August 13, 2025

Re: Seneca Avenue Reconstruction Project Public Meeting of July 16, 2025

Figure 7-32 from the 2024 AASHTO Bike Guide depicts a transition between a One-Way Separated Bike Lane and a Shared Lane through the intersection. We strongly encourage designers to include this configuration at the intersections with Norton and E Ridge Road.

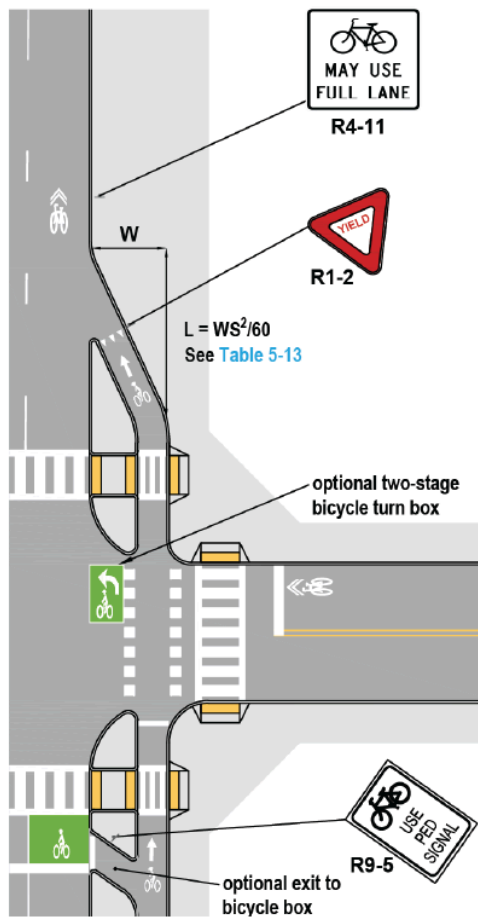
If a protected intersection is not practical, we encourage designers to carry the protected bike lane through the intersections at the project boundaries. **“In general, it is preferable for a transition from a separated bike lane to a standard bicycle lane or shared lane to occur on the far side of the intersection (see figures 7-32 and 7-33).**

This maximizes the safety and comfort of bicyclists through the intersection” (AASHTO Bike 7.10). Within the context of this project, we would recommend continuing the dedicated bike lane through the intersections of Norton and E Ridge similar to the design depicted in AASHTO 7-32. This design will allow for connectivity and allow drivers, cyclists, and pedestrians to have separate spaces which clearly communicate right-of-way and allow for safe crossing. Without a safe way for cyclists to cross the intersections at the project boundary, the cycle track will be severely underutilised. This design will also allow the future Joseph Ave project

Figure 7-28 from the 2024 AASHTO Bike Guide depicting a Floating Transit Stop Design with a Street-Level Protected Bike Lane crossing behind it. This same configuration can be used with a sidewalk level bike lane. Please refer to AASHTO 7.9.14 for detailed guidance.

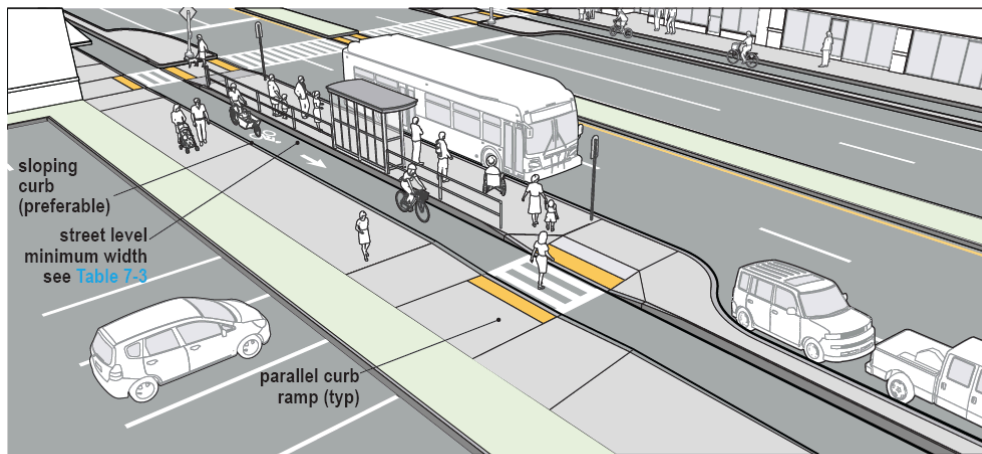
In our previous letter, we advocated for a floating bus stop design as discussed in AASHTO 7.9.14. We wanted to clarify that we are not talking about a temporary solution such as the vectorial bus stop platform as mentioned in the city's reply letter, but we are discussing a permanent solution. Floating bus stop islands are essentially large bump outs which use the parking lane to provide space for bus amenities and protected bike lanes. We encourage all bus stops in reconstruction projects with protected bike lanes to follow the design guidance described in detail in AASHTO's section 7.9.14.

Reconstruction projects are the opportunity to build these designs with concrete while milling and resurfacing projects should consider tools such as the vectorial modular bus stop platform when curb changes are beyond the project scope.
